**SPARE PART REPLACEMENT
CONDENSATION SOLUTION /CHANGE NEW HEATER FLIP MULLION**

All range of Multidoor refrigerators

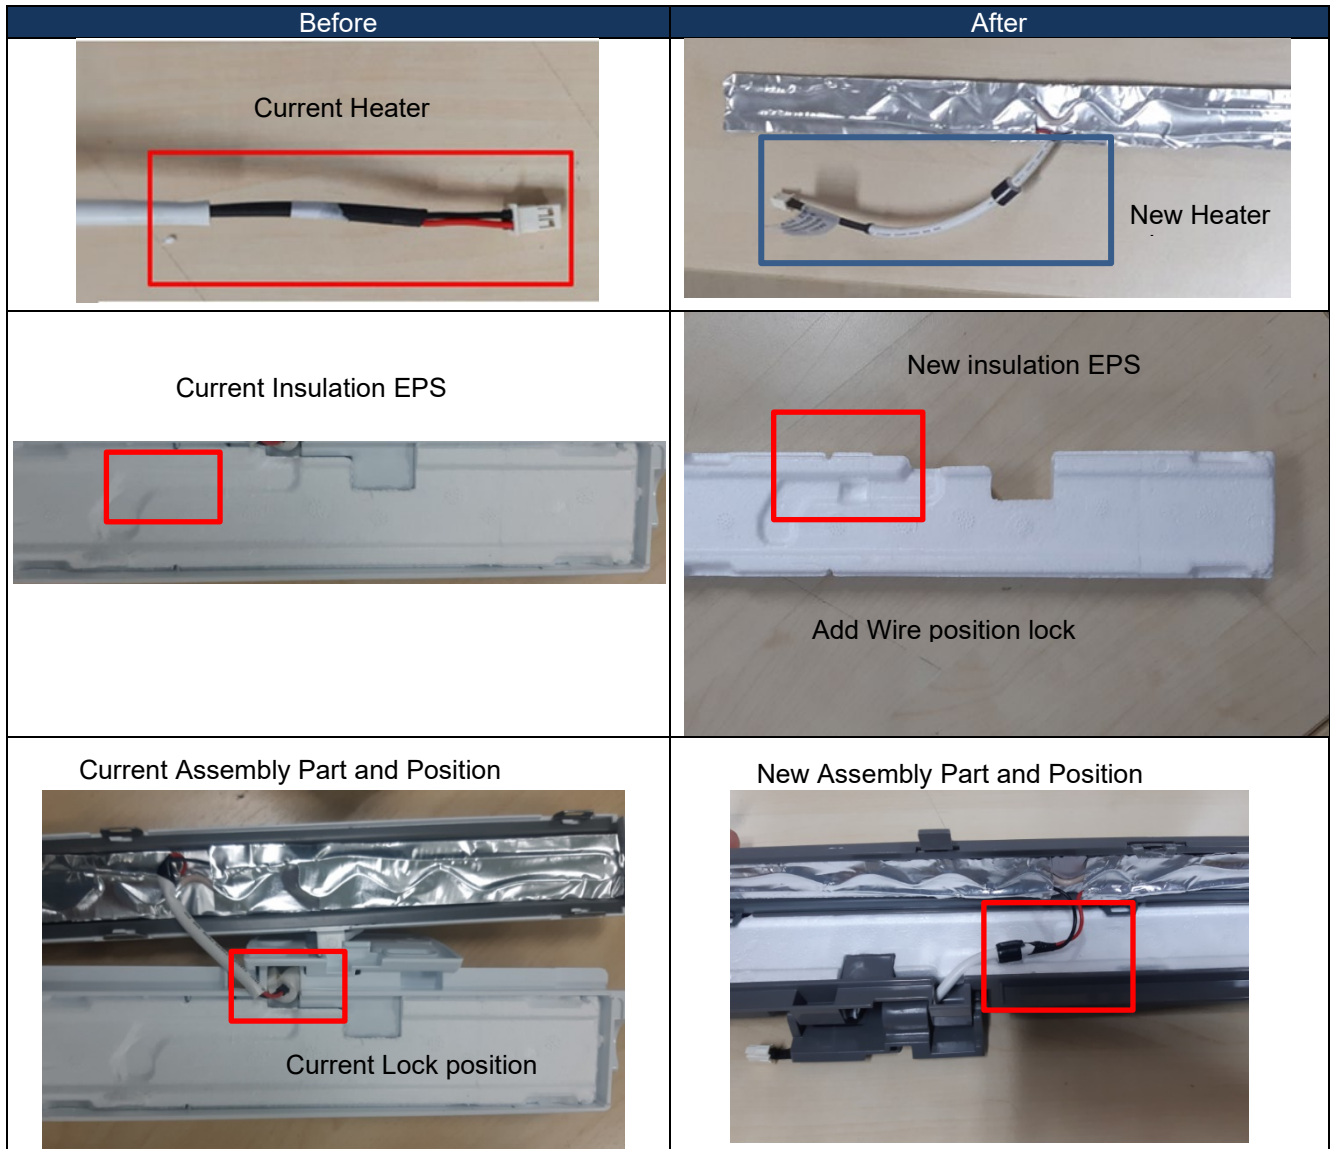
Due to condensation at flip mullion guide and FC door, the heater wiring part number 140045268012 (A04526803) was fold and torn.

Improve new concept locking PVC tube not to move and increase length of PVC and add clip support.
